Title - Sujet DIVING SUPPORT VEHICLES	
Solicitation No. - N° de l'invitation W8476-175501/A	Amendment No. - N° modif. 003
Client Reference No. - N° de référence du client W8476-175501	Date 2016-09-07
GETS Reference No. - N° de référence de SEAG PW-\$\$HP-371-71346	
File No. - N° de dossier hp926.W8476-175501	CCC No./N° CCC - FMS No./N° VME
Solicitation Closes - L'invitation prend fin at - à 02:00 PM on - le 2016-09-27	Time Zone Fuseau horaire Eastern Daylight Saving Time EDT
F.O.B. - F.A.B. Plant-Usine: <input type="checkbox"/> Destination: <input checked="" type="checkbox"/> Other-Autre: <input type="checkbox"/>	
Address Enquiries to: - Adresser toutes questions à: Modérie, Christine	Buyer Id - Id de l'acheteur hp926
Telephone No. - N° de téléphone (873) 469-3327 ()	FAX No. - N° de FAX (819) 953-2953
Destination - of Goods, Services, and Construction: Destination - des biens, services et construction:

AMENDMENT 003

- A. Respond to bidder's questions;**
- B. Post illustrations;**
- C. Update Purchase Description (ANNEX B).**

Figure 1 a

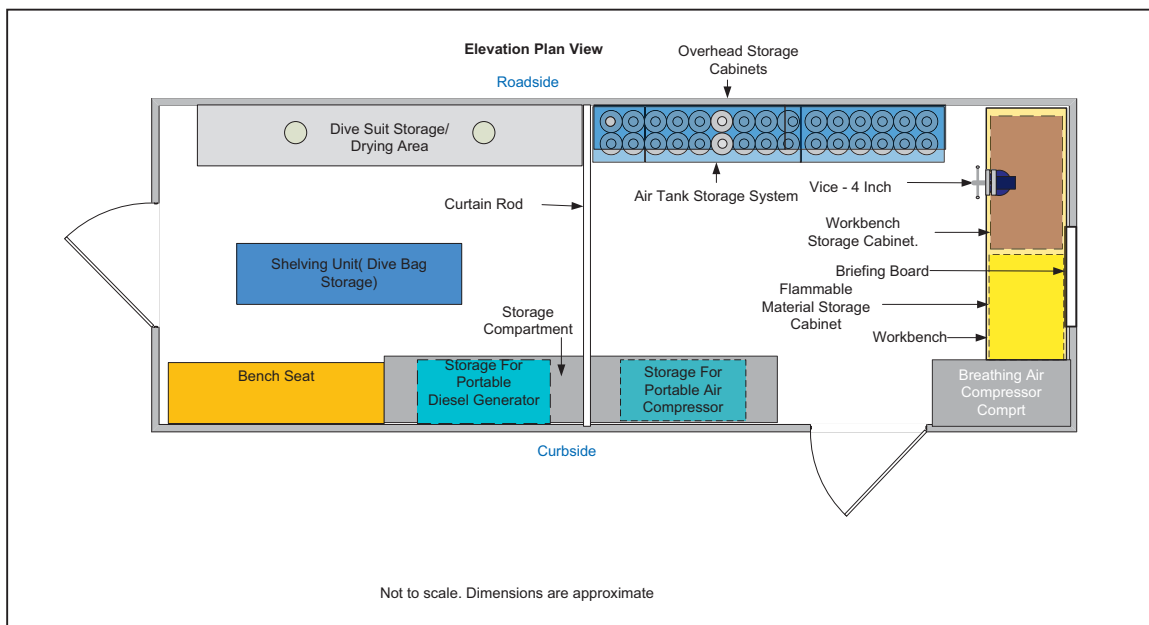
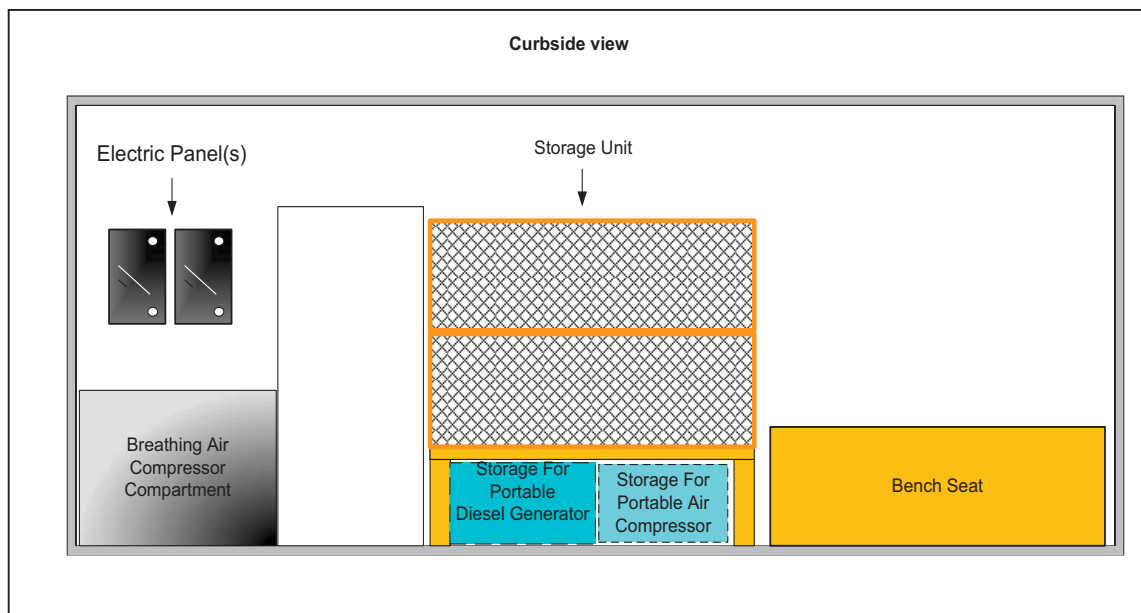
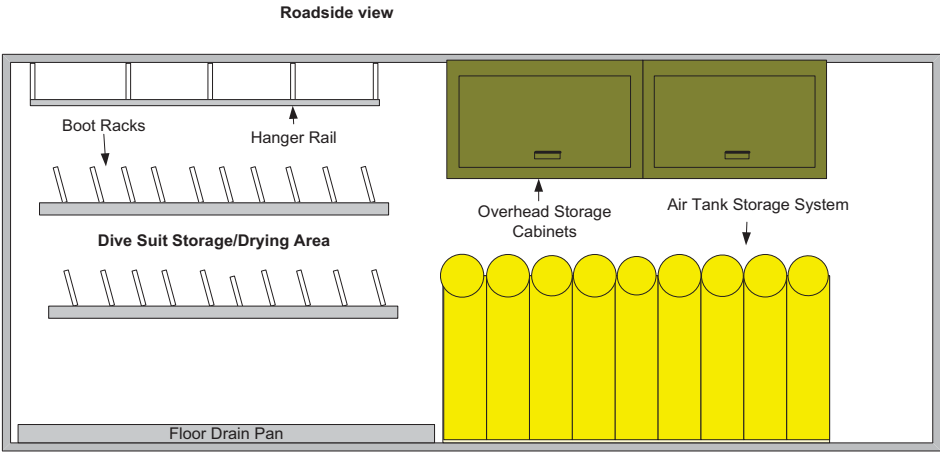
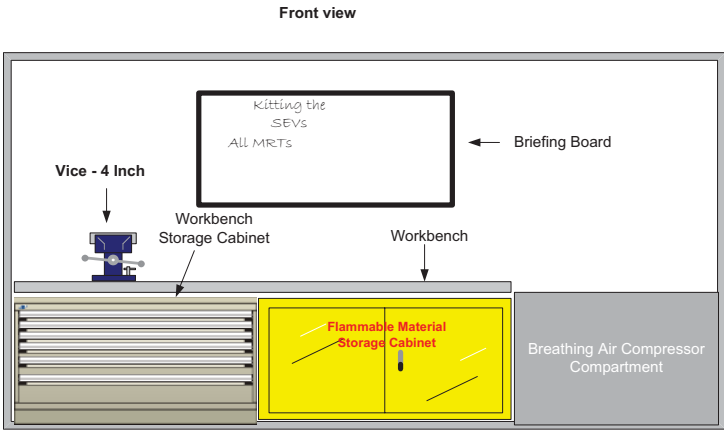
Question 12: The desired body width dimension is called up as 2.6 M wide which is 102 inches but the dimension in Imperial units as called up in the document is 8 ft. (96 inches) Can the desired width be confirmed ?

Answer 12: The body width dimension shall be 2, 6 m (8, 5 foot).

Public Services and Procurement Canada (PSPC) is to amend paragraph 3.20.1 (g) ii to read: The van body shall have a nominal width of 2, 6 m (8, 5 foot);
